T10/07-409r1

To INCITS T10 Committee From Michael Banther, HP Subject SSC-3 Volume Model

Date
18 September 2007

Figure 3 – Typical ~~volume~~ recording medium layout

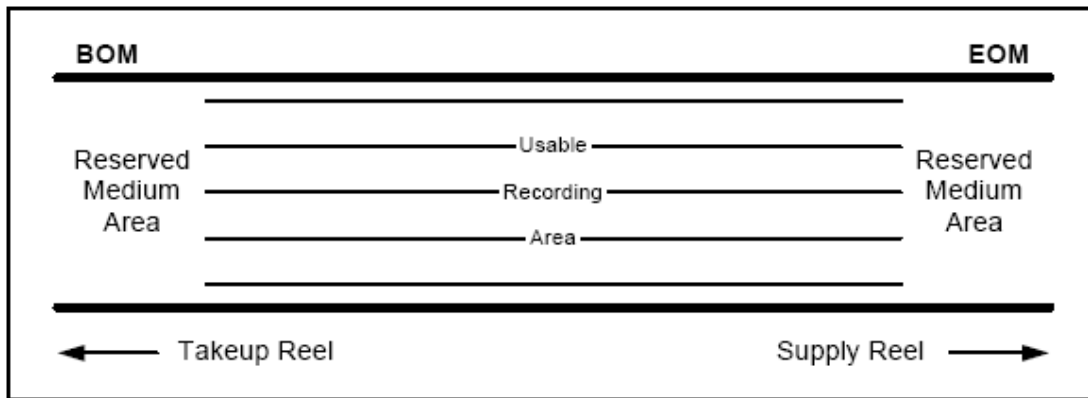
As shown in figure 3, a portion of the physical length of recording medium is not usable for recording data. For most data volumes, a length of the recording medium is reserved between the take-up reel and the beginning-of-medium, and between the end-of-medium position and the supply reel. This is done to provide a sufficient tape wrap onto the reel hub and to ensure that recording starts in an undamaged section of the medium.

Figure 4 – Typical recording medium track layout

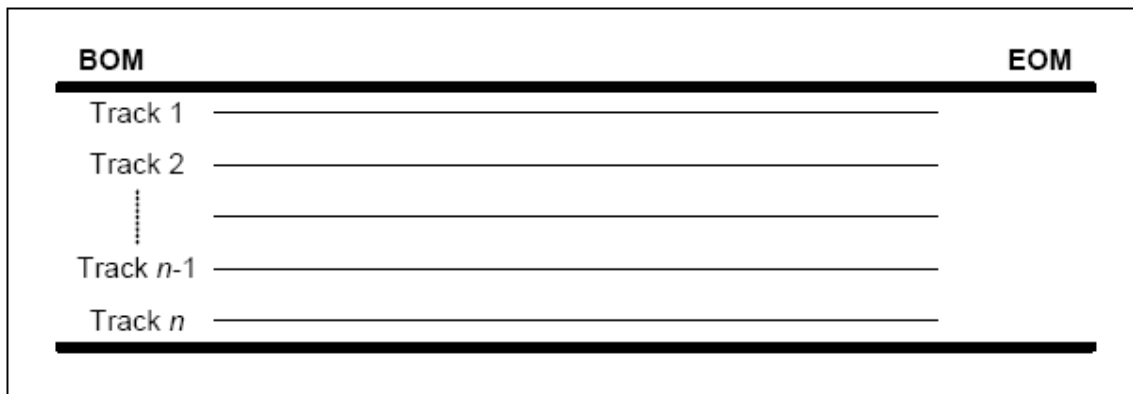
The position on the recording medium where one write component records a pattern of recorded signals ~~may be written by one write component~~ is called a track (see figure 4). A device may write or read from one or more tracks at a time, depending on the format.

Figure Y – Typical cleaning medium layout

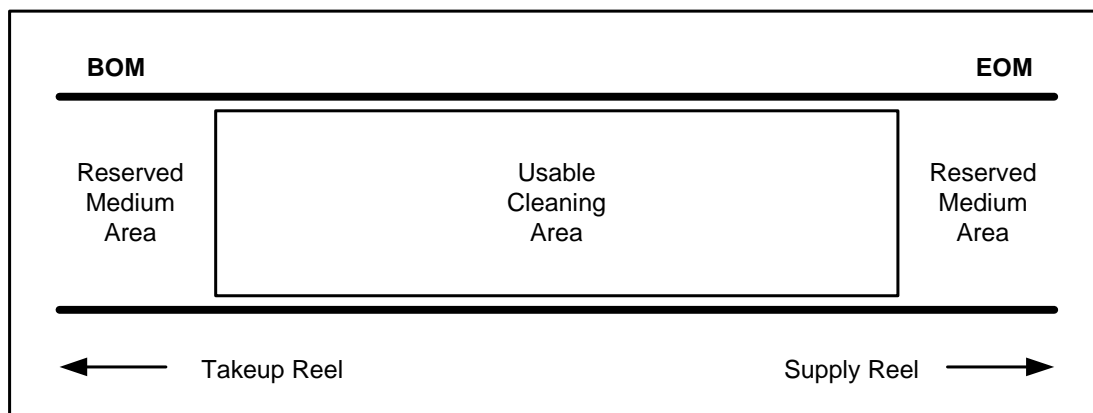
As shown in figure Y, a portion of the physical length of a cleaning medium is not usable for abrading the read/write mechanism. For most cleaning volumes, a length of the cleaning medium is reserved between the take-up reel and the beginning-of-medium, and between the end-of-medium position and the supply reel. This is done to provide a sufficient tape wrap onto the reel hub and to ensure that interactions between the abrasive substrate and the read/write mechanism start in an undamaged section of the medium.
